## HISTORIC AND DESIGN REVIEW COMMISSION

June 05, 2019

**HDRC CASE NO:** 2019-224  
**ADDRESS:** 515 BURLESON ST  
**LEGAL DESCRIPTION:** NCB 514 BLK 18 LOT 9  
**ZONING:** R-6, H  
**CITY COUNCIL DIST.:** 2  
**DISTRICT:** Dignowity Hill Historic District  
**APPLICANT:** Stephanie Padua/TexPro Painting and Renovations  
**OWNER:** Patricia Gonzales  
**TYPE OF WORK:** Window replacement, porch steps replacement, paint  
**APPLICATION RECEIVED:** April 16, 2019  
**60-DAY REVIEW:** June 15, 2019  
**CASE MANAGER:** Huy Pham

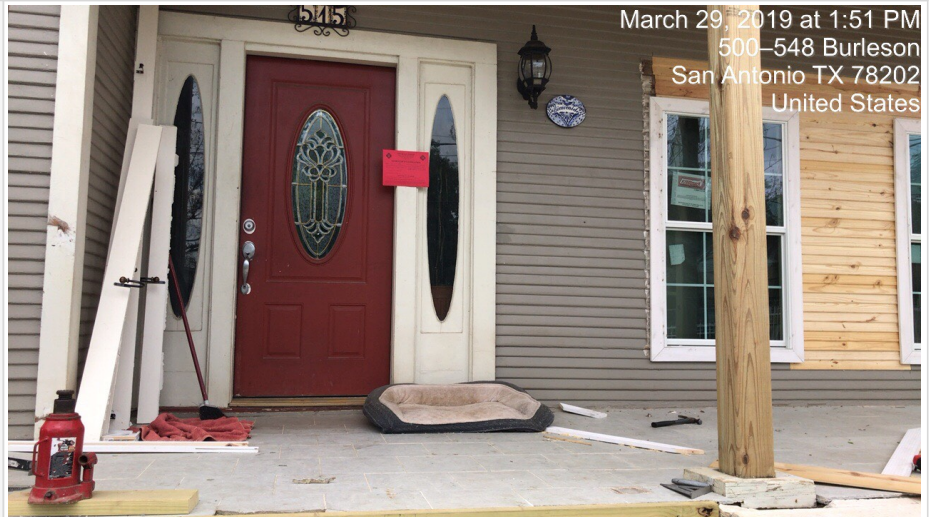
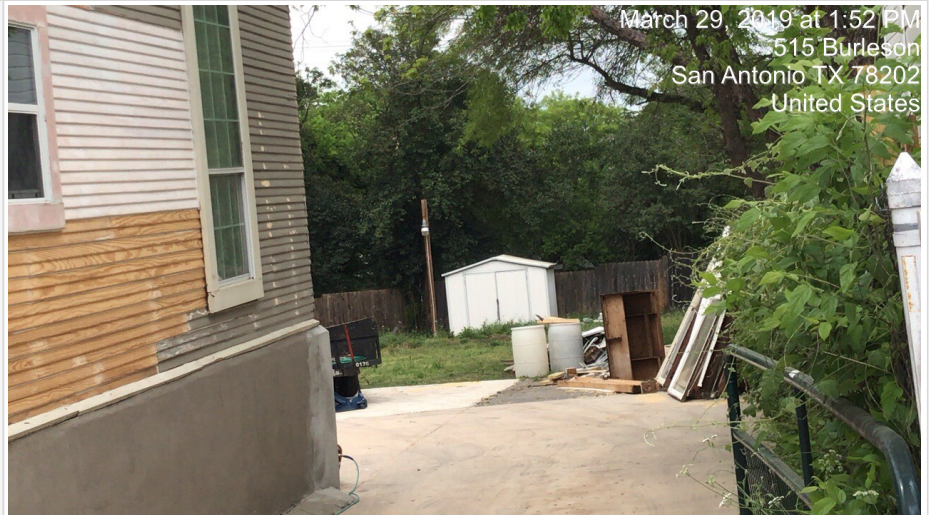
Date	03/29/2019
Time	01:47 PM (-5 GMT)
Context	drive-by
Present Staff	Huy Pham, Adam Rajper
Present Individuals	None
Types of Work Observed	Exterior Maintenance and Alterations
Amount of Work Completed	75%
Description of work	Window replacement on nearly all windows, front porch modifications to skirting and columns. Wood windows sashes are visible in the front yard and rear of driveway.
